Re: Reliance Letter, 1444-1458 Cawthra Road, Mississauga, Ontario

As requested, HGC Engineering has prepared this letter to address the revised site plan, attached, prepared by KFA Architects + Planners dated August 13, 2019. Our latest noise report for this site is entitled, “Noise Feasibility Study, Proposed Residential Development, 1444 – 1458 Cawthra Road, Mississauga, Ontario” dated December 19, 2019. This letter is being prepared in response to the City of Mississauga’s comments dated March 20, 2020.

Site Plan

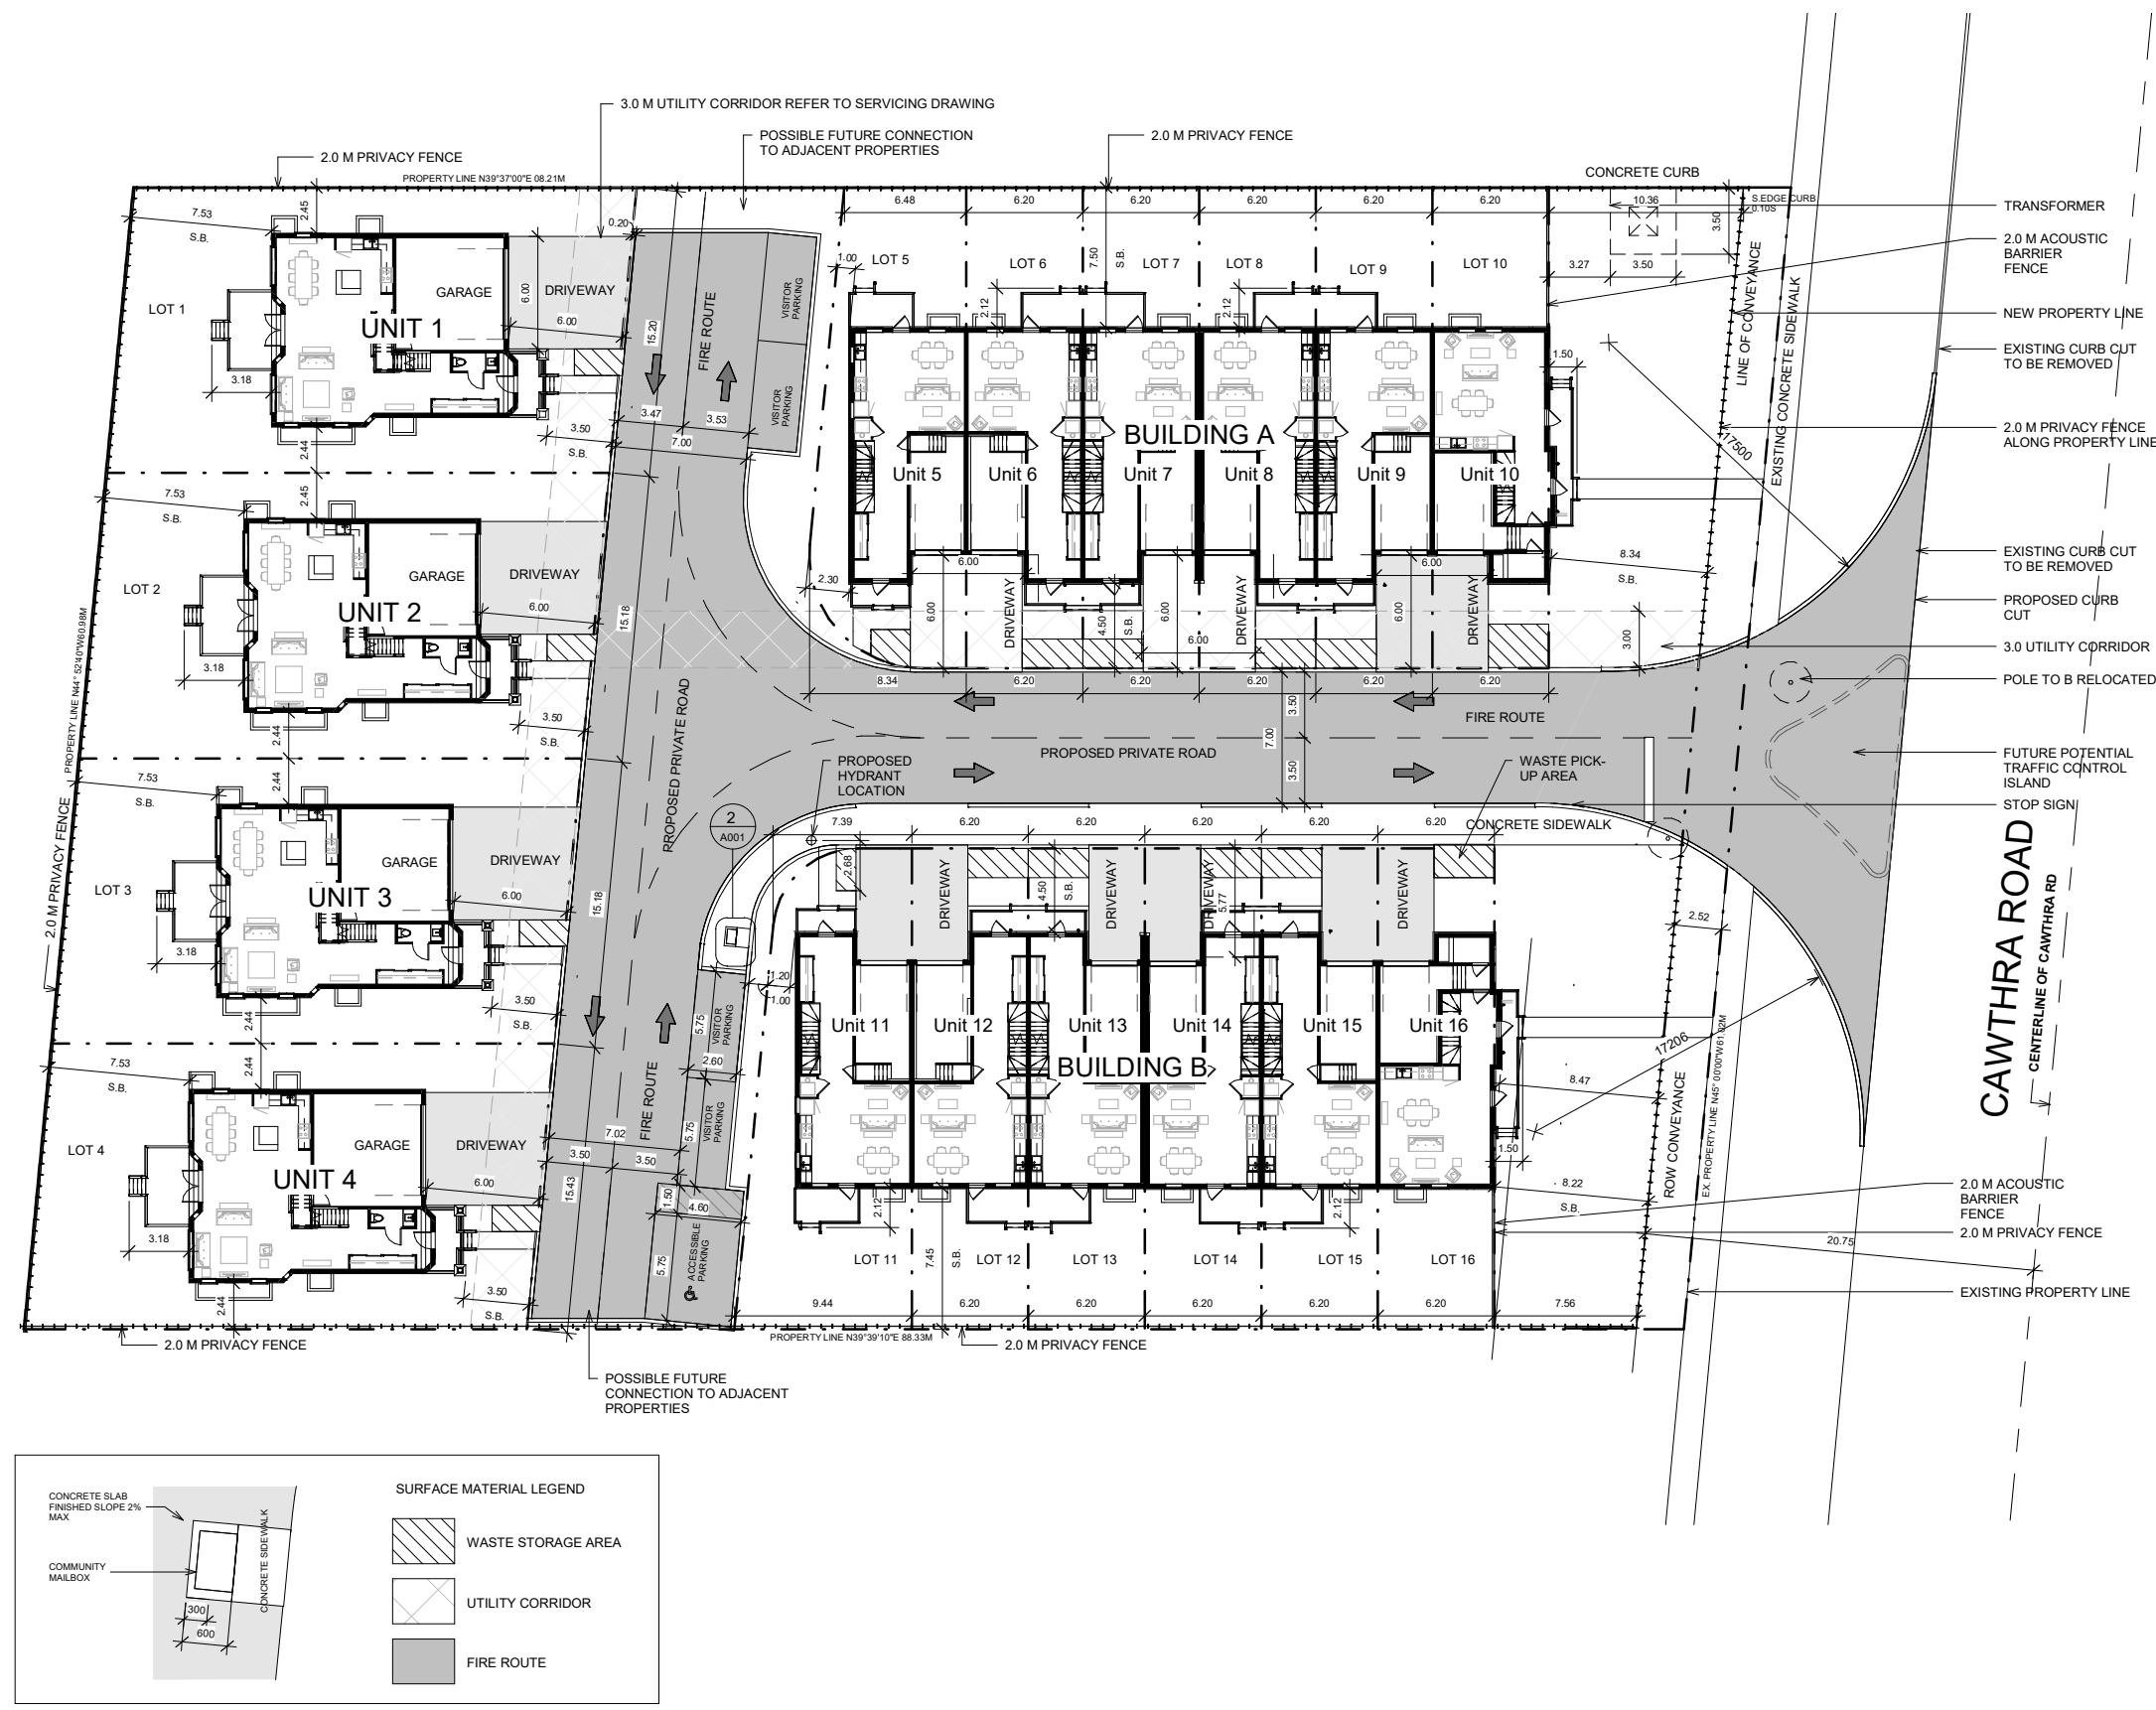
Since our report, the site plan has been revised slightly. The minor changes to the site plan do not affect the acoustic recommendations contained in our December 19, 2019 noise report.

The recommendations contained in our December 19, 2019 noise report remain valid. Tables IV and V from our report has been reproduced below with no changes.
